Value Engineering Study

Final Report

VE Number: 202303

I-75 Widening, MP 20.2 to MP 28.851 Laurel & Whitley Counties

31

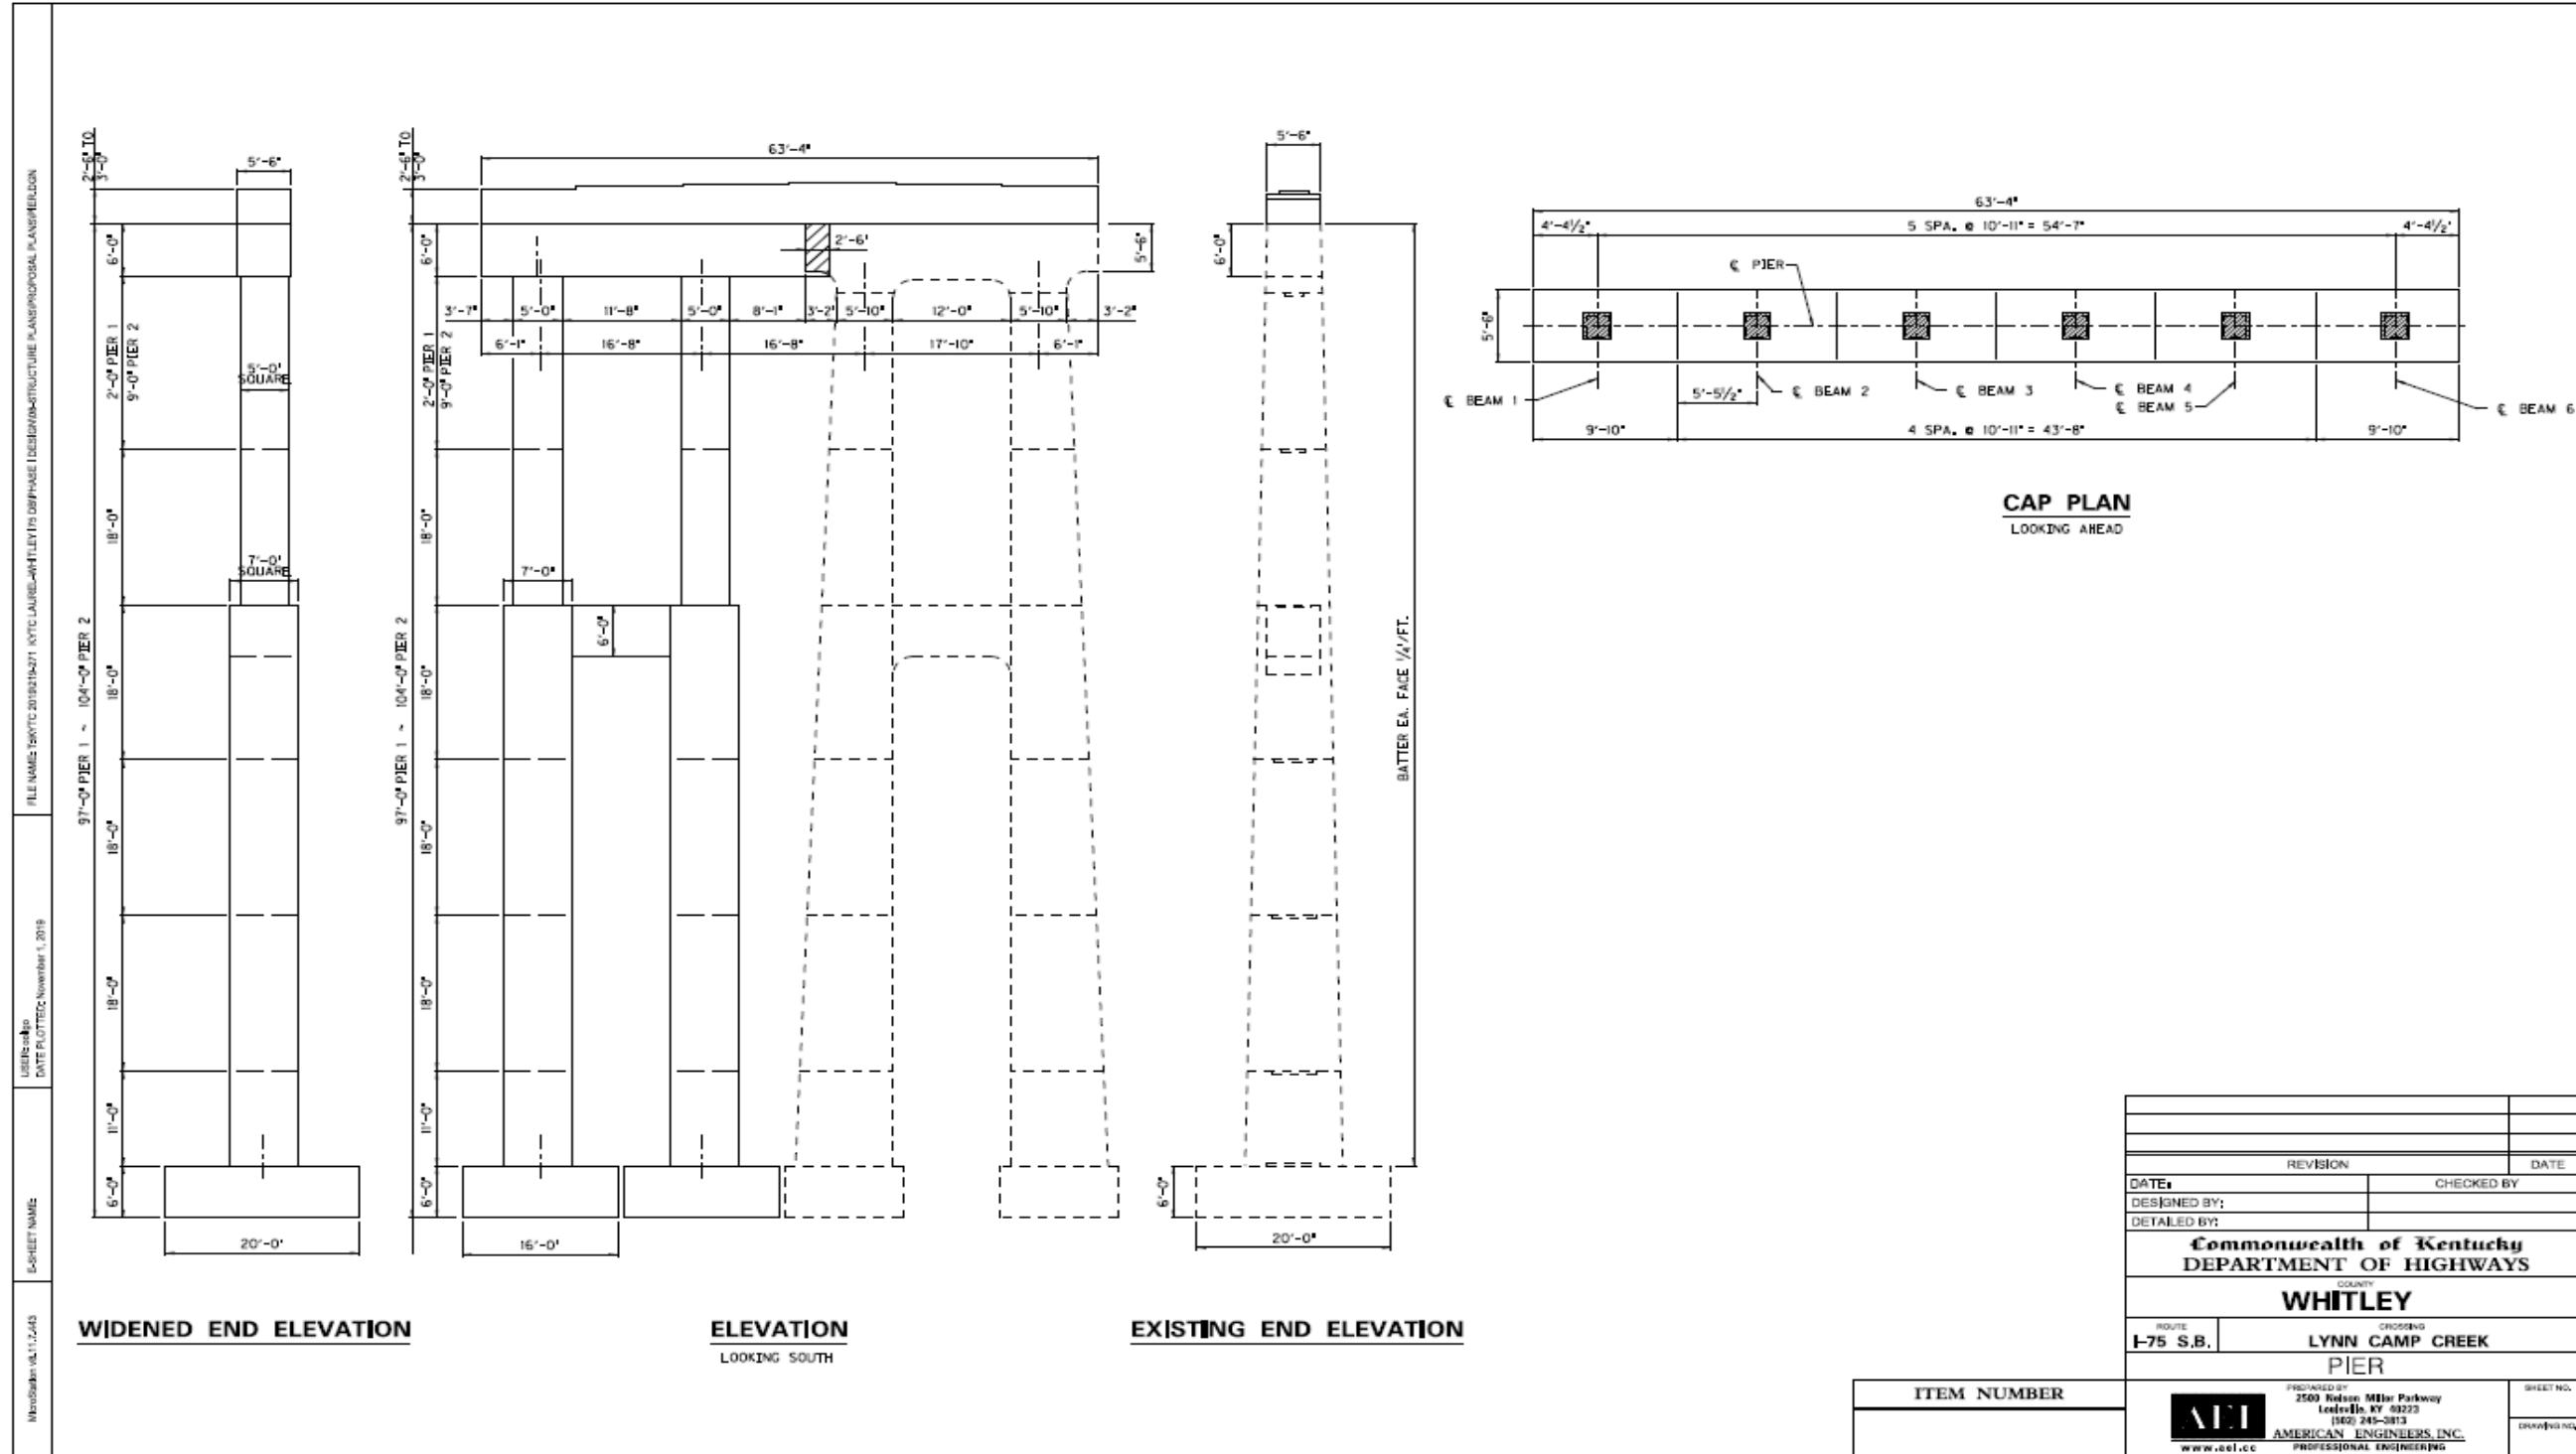
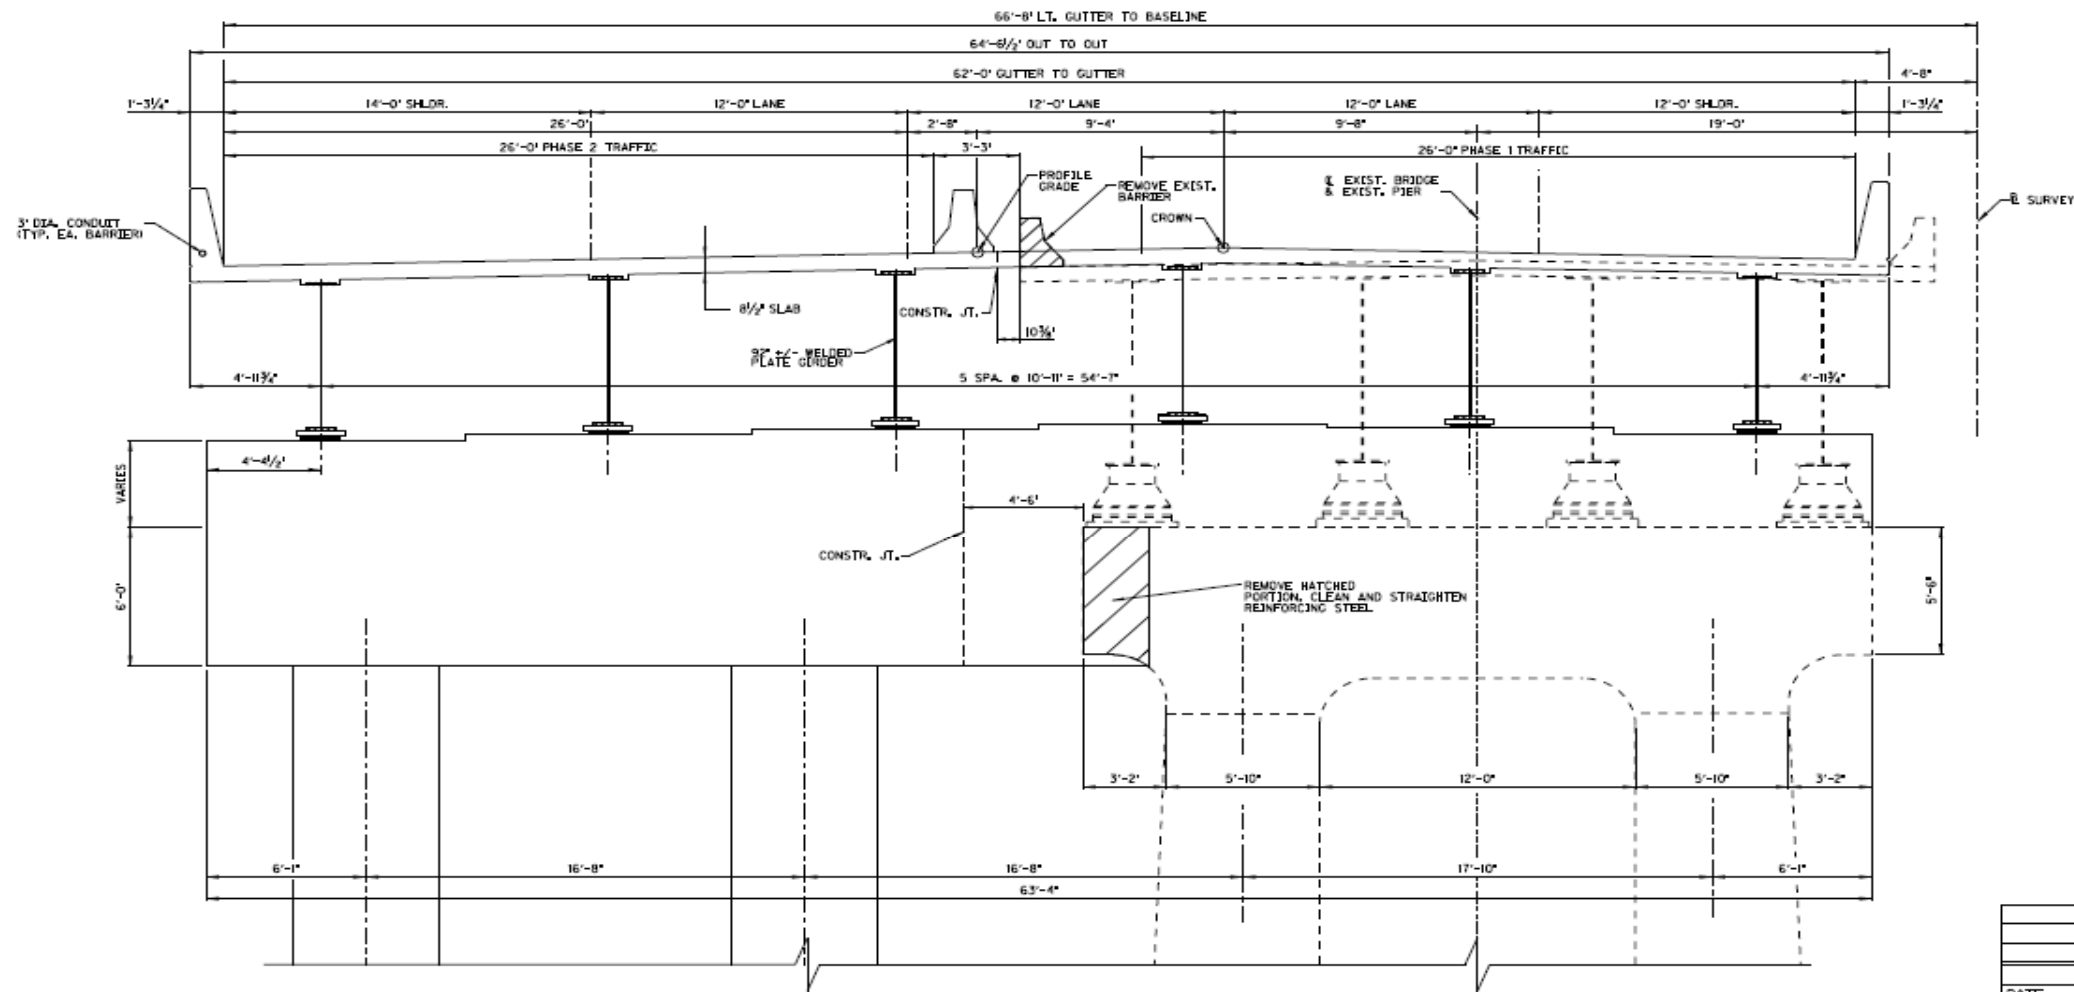
TITLE	Reuse substructures for Lynn Camp Bridge		
VALUE PROPOSAL SYNOPSIS:			
Reuse existing substructure at the Lynn Camp Creek bridge. Cost savings and time savings can be realized by using the existing substructures.			
 Reliability	Maintained	 Functionality	Maintained
 O&M	Maintained	 Schedule Impact	Improved
			\$ Initial Cost Avoidance (Add)
			\$3,392,000
BASELINE CONCEPT:			
The existing structures would be replaced with completely new structures.			
VALUE PROPOSAL DESCRIPTION:			
Widen and reuse existing substructure at Lynn Camp Creek to reduce schedule and reduce cost.			
ADVANTAGES:		DISADVANTAGES:	
● Cost savings		● Not a new structure	
● Easier constructability		● May need to repair (epoxy inject)	
● Shorter construction		● May need to strengthen	
●		●	
●		●	
●		●	
●		●	
\$ COST SUMMARY		Initial Costs	O&M Costs
		Total Life Cycle Cost	
BASELINE CONCEPT:		\$19,526,000	\$0
VALUE PROPOSAL DESCRIPTION:		\$16,134,000	\$0
